SERVICE BULLETIN

Machines/Models: X20W
X26N

SERVICE BULLETIN: 94.11, THE INSTALLATION OF THIS KIT IS MANDATORY!
THIS KIT **MUST** BE INSTALLED AS SOON AS POSSIBLE.

PURPOSE: Notification of requirement to add lift relief valve.

Figure 1

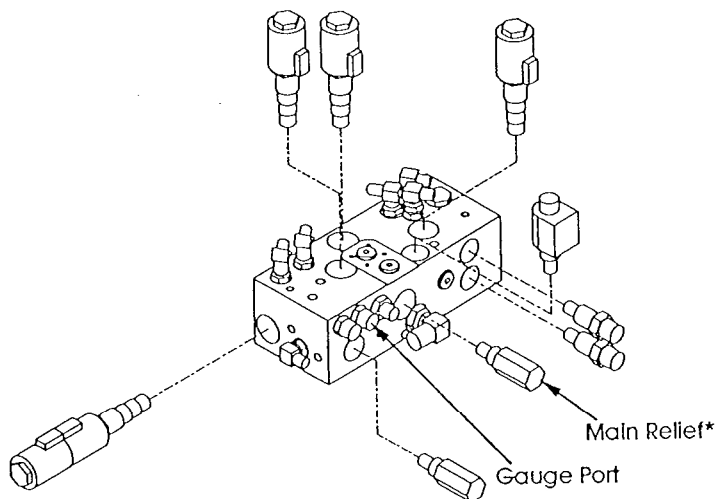
Control Valve: Serial Numbers 1000-1401

Control Valve: Serial Numbers 1402-Current

*-Valves shown removed for clarity only,
no removal is necessary.

IN-LINE RELIEF KIT X20W / X26N

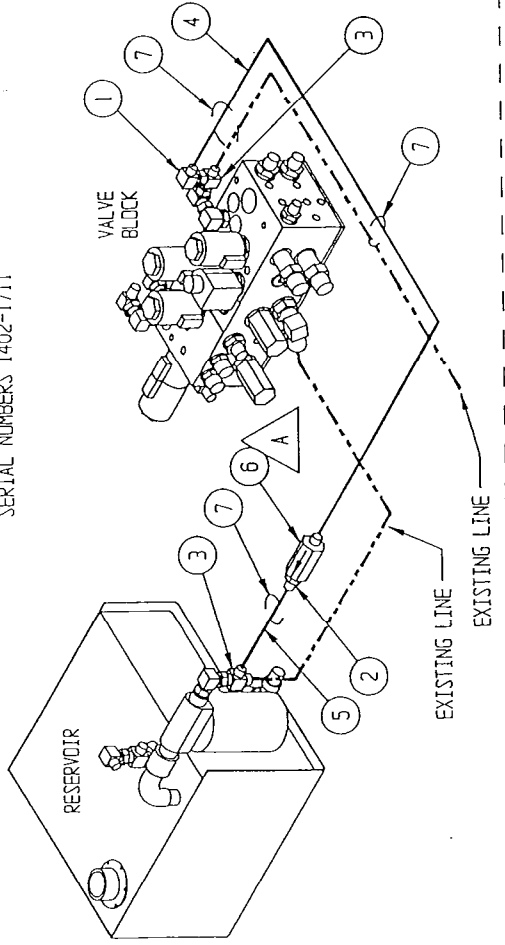
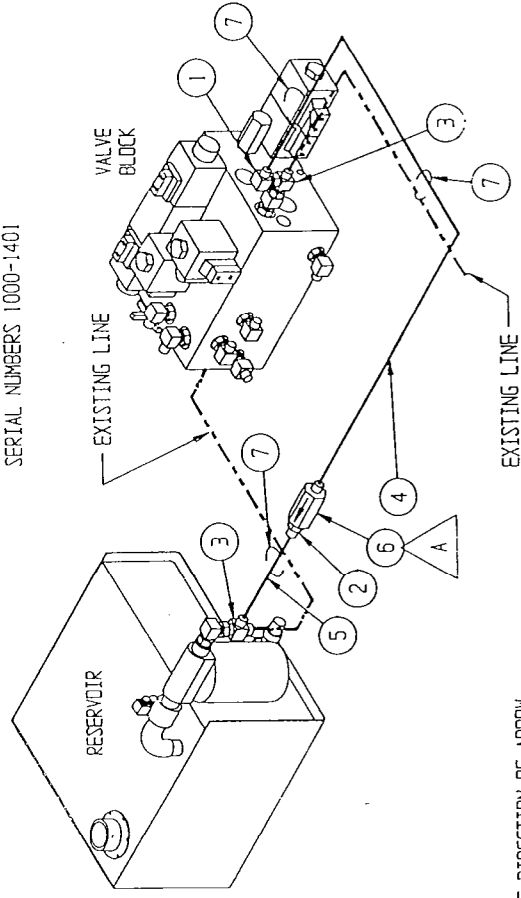
OPERATION REQUIRED: Installation of relief valve.

INSTRUCTIONS:

1. DISCONNECT NEGATIVE BATTERY TERMINAL.
2. REMOVE LIFT HOSE FROM VALVE BLOCK.
3. INSTALL TEE FITTING ATTACHED TO LONG HOSE TO EXISTING FITTING ON VALVE BLOCK. NOTE DIRECTION OF ARROW ON RELIEF VALVE.
4. INSTALL LIFT HOSE TO NEW TEE FITTING.
5. REMOVE RETURN LINE FROM FILTER.
6. INSTALL TEE FITTING ATTACHED TO SHORT HOSE TO EXISTING FITTING ON FILTER.
7. INSTALL RETURN HOSE TO NEW TEE FITTING.
8. TORQUE ALL FITTING TO 10-20 FT. LBS.
9. TIE WRAP RELIEF AND NEW HOSES TO EXISTING HOSES TO KEEP AWAY FROM MOTOR.
10. REINSTALL NEGATIVE BATTERY TERMINAL.
11. TEST MACHINE FOR LIFT FUNCTION.
